**CLOMR-TO-LOMR SUPPLEMENTAL DATA
FOR
BULLARD WASH CHANNEL IMPROVEMENT**

IN REPLY REFER TO:
Case No.: 01-09-124P

Community: City of Goodyear, AZ
Community No.: 040046
Panel Affected: 04013C2070 F
Effective Date of **FEB 27 2001**
This Revision:

Identifier:	Bullard Wash Channel Improvements
Flooding Source:	Bullard Wash
FIRM Panel(s) Affected:	04013C2070 F

627P

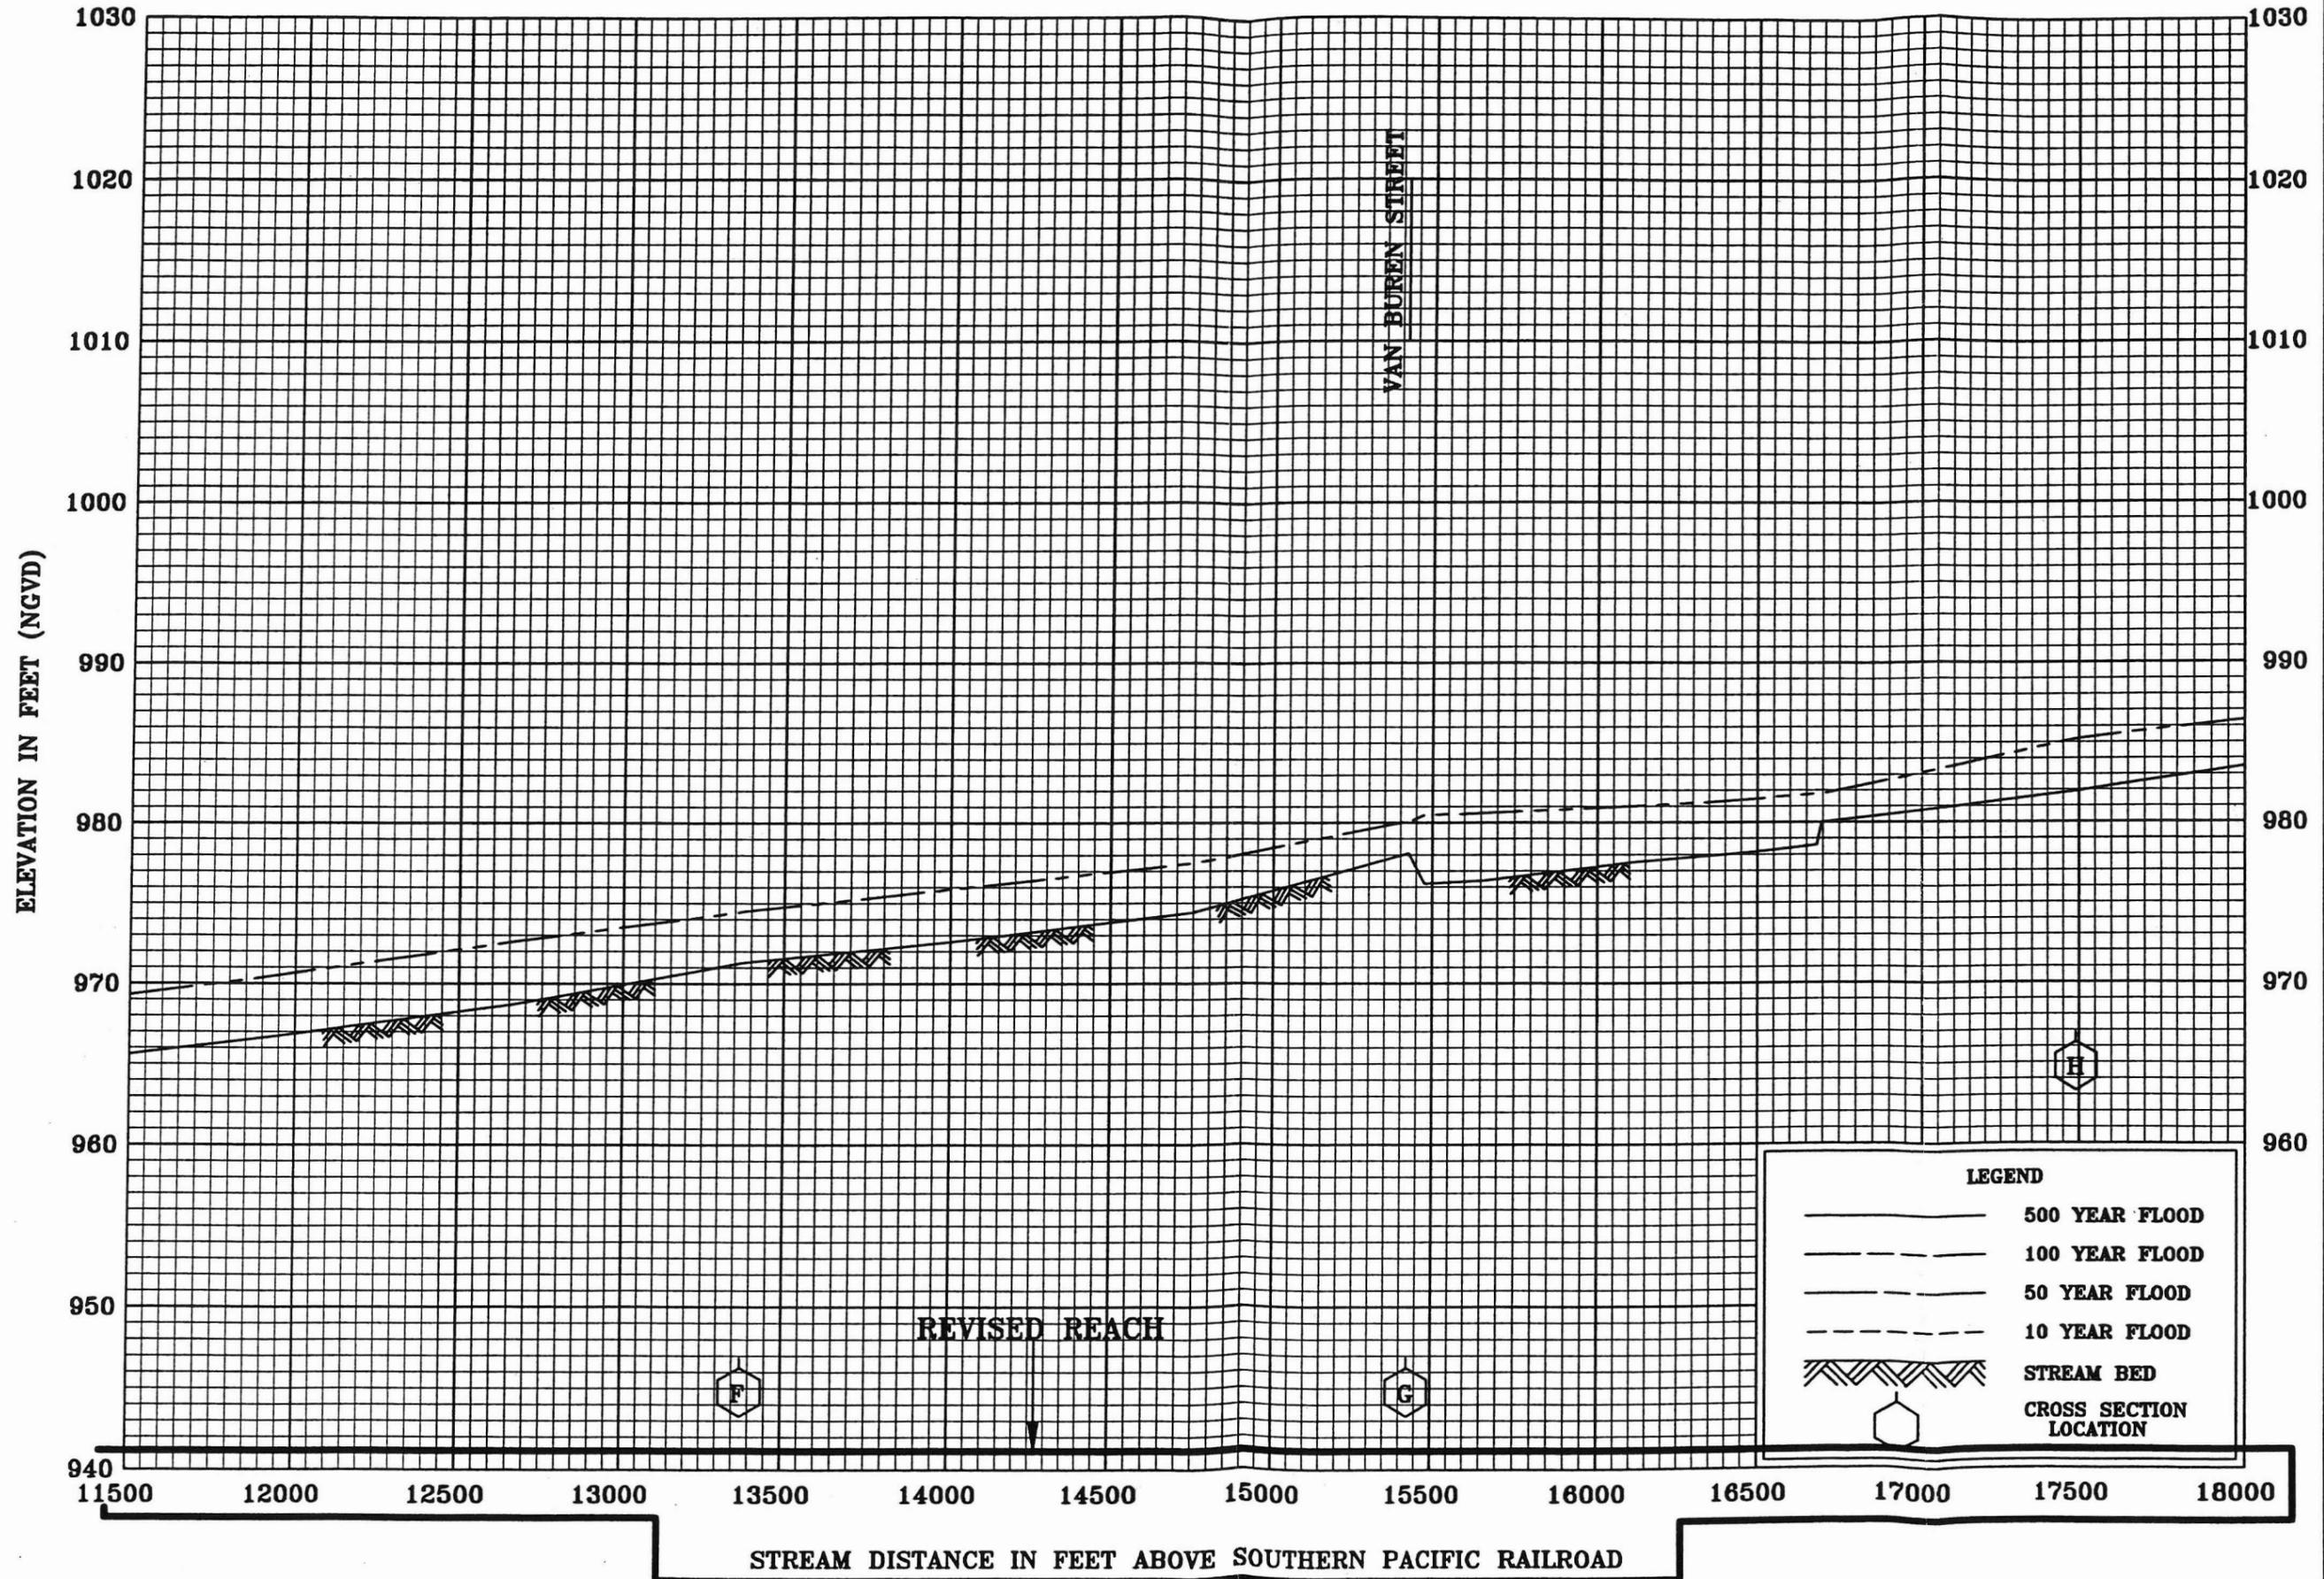
We have completed our review of the submitted data and the flood data shown on the effective FIRM and in the effective FIS report. We have revised the FIRM and FIS report to modify the elevations and floodplain and floodway boundary delineations of the flood having a 1-percent chance of being equaled or exceeded in any given year (base flood) along Bullard Wash. As a result of the modifications, the Base Flood Elevations (BFEs) for Bullard Wash from approximately 3,300 feet downstream to approximately 450 feet downstream of Lower Buckeye Parkway (extended) and the widths of the Special Flood Hazard Area (SFHA), the area that would be inundated by the base flood, and the regulatory floodway decreased. The base flood is contained in the Bullard Wash channel from its mouth to approximately 2,100 feet downstream of Lower Buckeye Parkway (extended) and in East Tributary Channel from the confluence with Bullard Wash to approximately 2,000 feet upstream. A floodwater ponding area designated as Zone AH, an SFHA with flood depths between 1 foot and 3 feet and with BFEs determined, was added to the FIRM just northeast of the intersection of Buckeye Canal and the Bullard Wash channel. The modifications are shown on the enclosed annotated copies of FIRM

Panel 04013C2070 F, Profile Panels 626P through 631P, and affected portions of the Floodway Data Table. This LOMR hereby revises the above-referenced panel of the effective FIRM and the affected portions of the FIS report, both dated September 30, 1995.

FLOOD PROFILES
 BULLARD WASH
 REVISED TO REFLECT LOMR
 DATED FEB 27 2001
